Submitted on Fri, 13/03/2020 - 14:28
Submitted by: Anonymous
Submitted values are:
Submission Type:I am making a personal submission
First Name: Mary-Anne
Last Name: Gayed
Name Withheld: No

RE: CONCEPTUAL REGIONAL FLOOD MITIGATION STRATEGY, LAND AT MAY AVENUE ROSSMORE AND KEVIN PARK DRIVE BRINGELLY – SOUTH CREEK PRECINCT, ROSSMORE NSW

FIGURE 1: CURRENT ZONING PROPOSAL

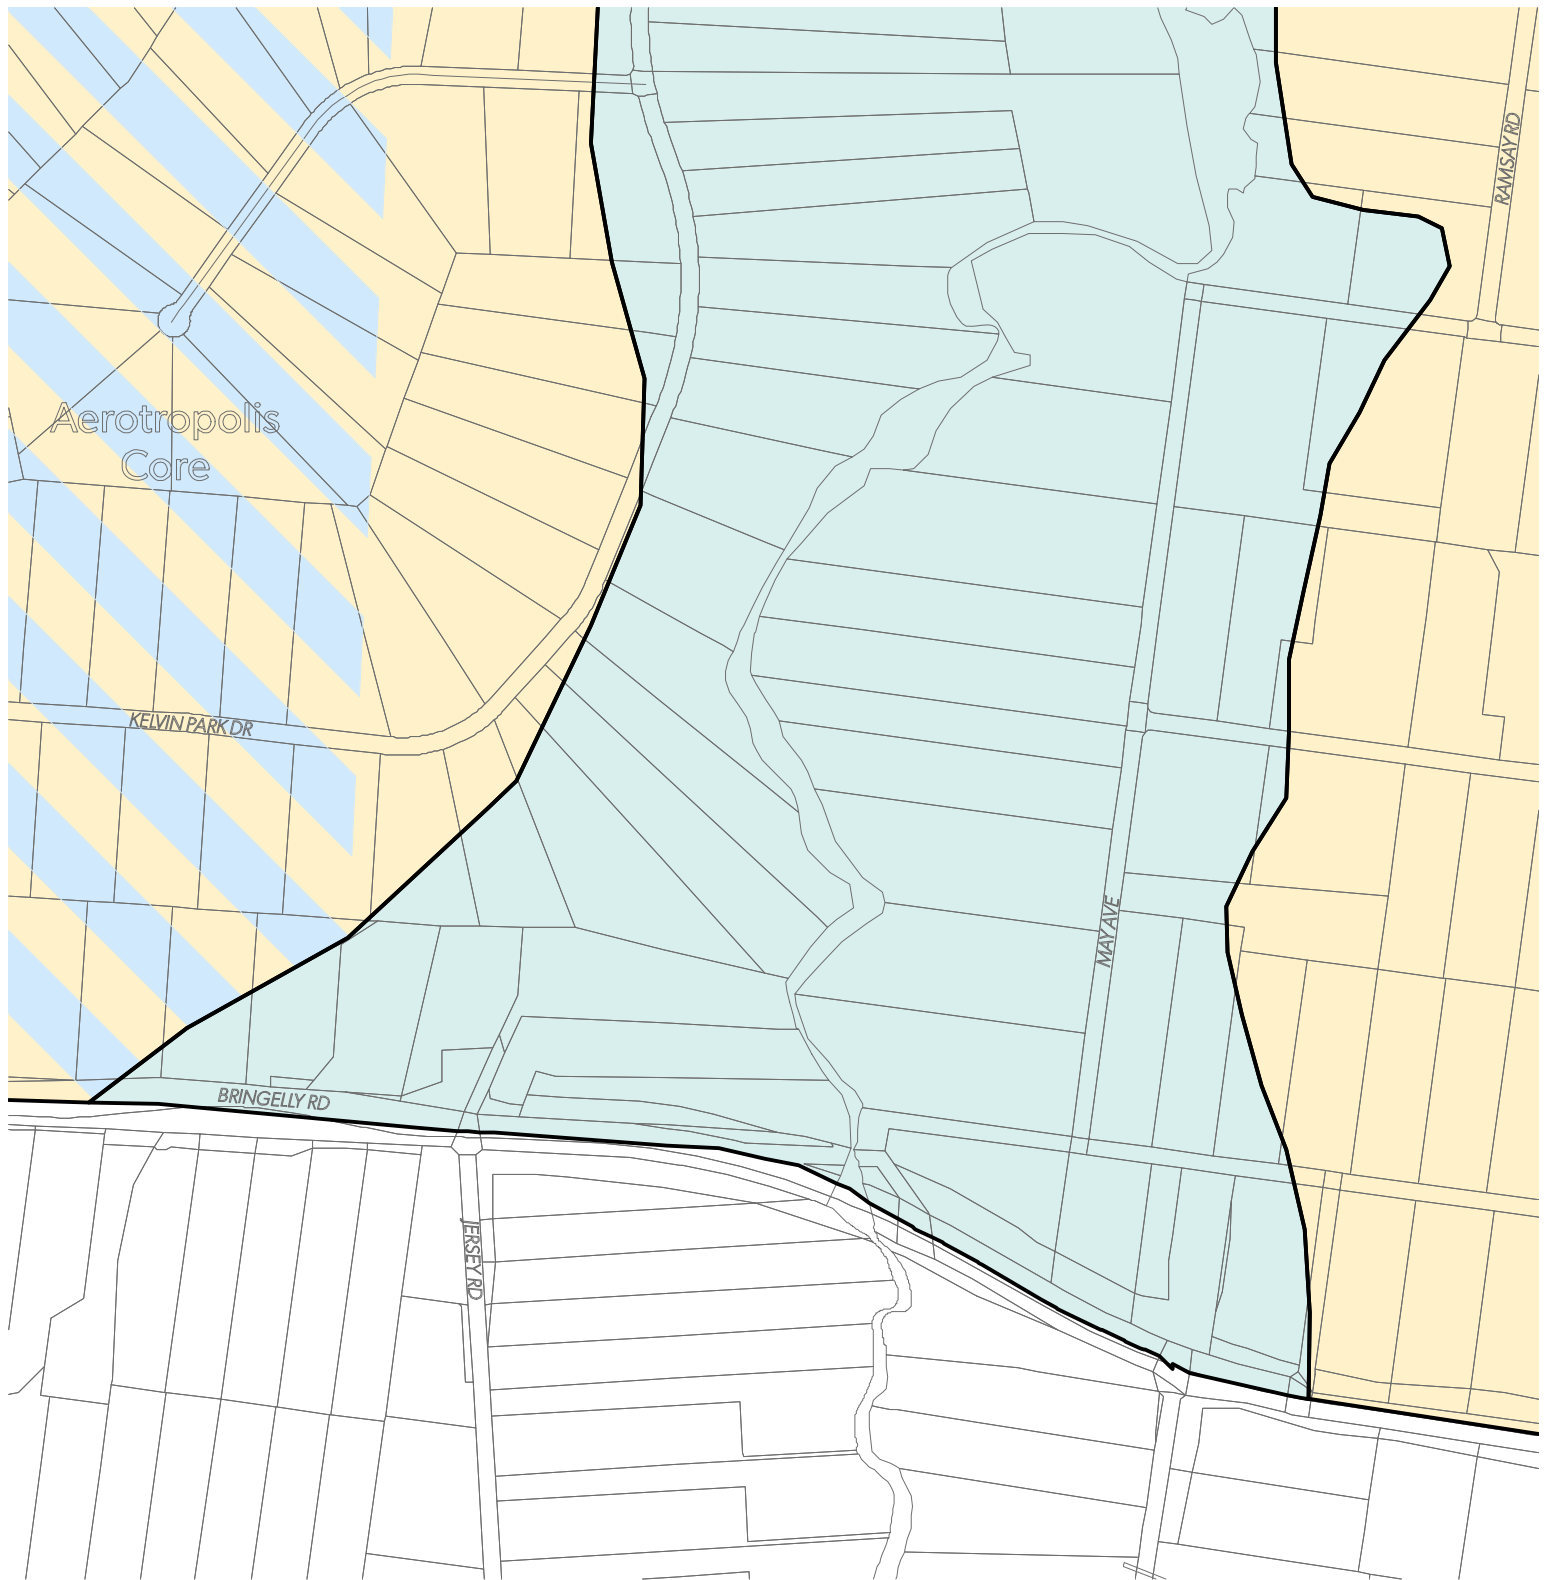
The current proposed general zoning category of 'urban' and 'non-urban' land are provided at Figure 1. We observe the following in respect of these boundaries:

1. The non-urban land encompasses flood liable land to the PMF and in many areas, even land that is above the PMF.
2. The non-urban land is centred on South Creek and presents as a corridor which varies between say 700-800 m in width. The width is far more than is necessary to carry upstream stormwater flows. It is likely that if such a width were ultimately adopted, that it may be difficult to achieve a number of the precinct objectives such as a useable interface between urban and non-urban land and provision of efficient connections across water ways.

3. It is our view that a narrow 'environmental corridor' which would range say between 250-450 m in width, would be more than adequate to carry upstream stormwater flows, as well as being capable of satisfying the precinct objectives. A narrower corridor would also mean that fewer properties would ultimately be integrated into the non-urban category, this translates into better efficiencies in achieving environmental outcomes within the corridor.

FIGURE 2: PROPOSED CONCEPT FLOOD MITIGATION STRATEGY AND ALTERNATIVE ZONING FOR PRECINCT

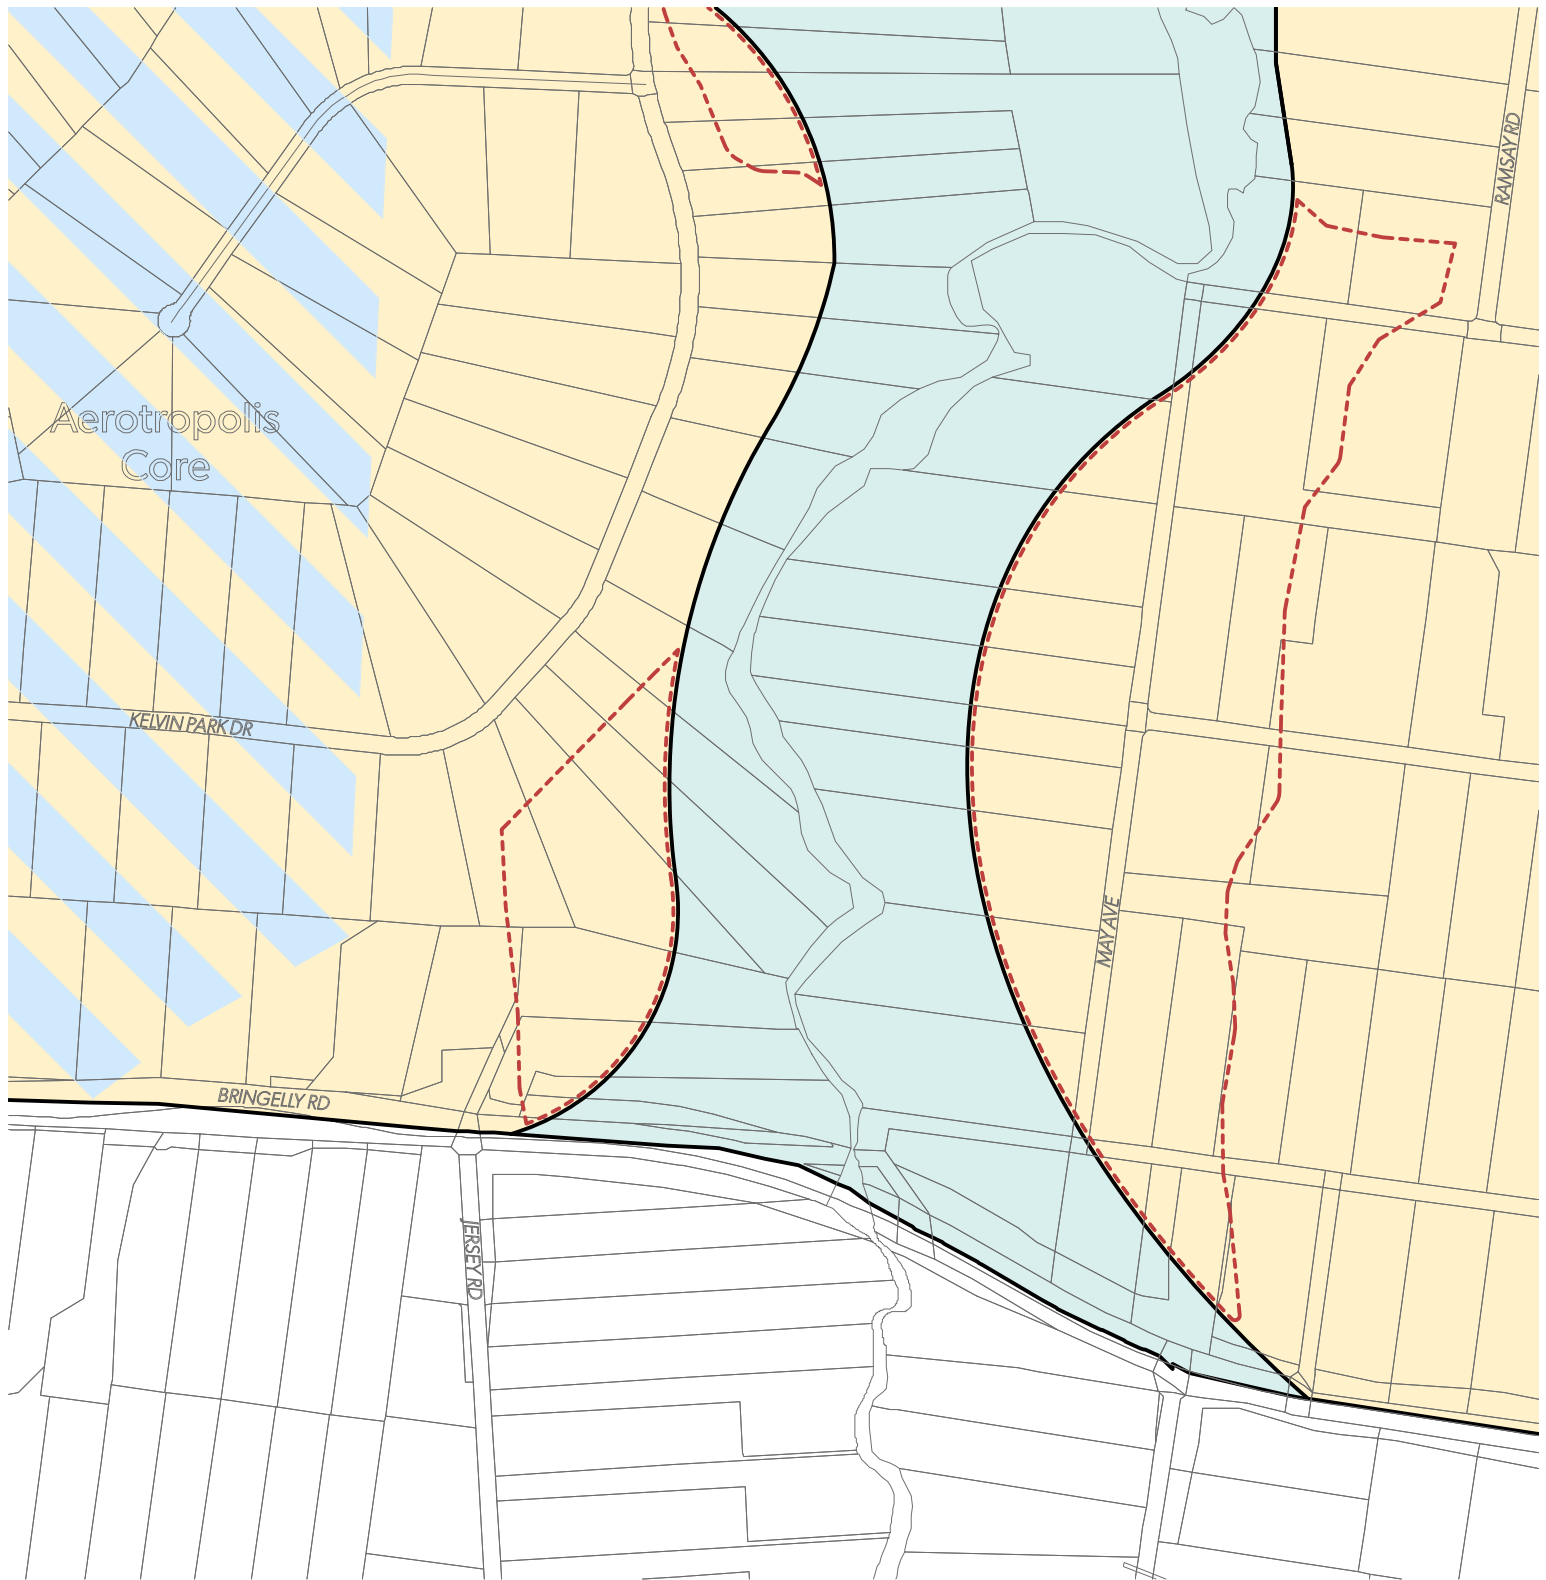
The concept FMS is provided at Figure 2 and Figure 3. Figure 2 provides a plan of the alternate broad 'urban' and 'non-urban' zoning categories, also indicating the areas where earthworks would be required to achieve ground levels at the PMF. Figure 3 provides a typical schematic section through the ultimate environmental corridor. The following comments are made in respect of the alternative scheme:

1. The alternate scheme will deliver a better opportunity to meet the precinct objectives.
2. The alternate scheme would ensure adequate conservation and rehabilitation of riparian land.
3. The alternate scheme would enable efficient connectivity between urban and non-urban land.
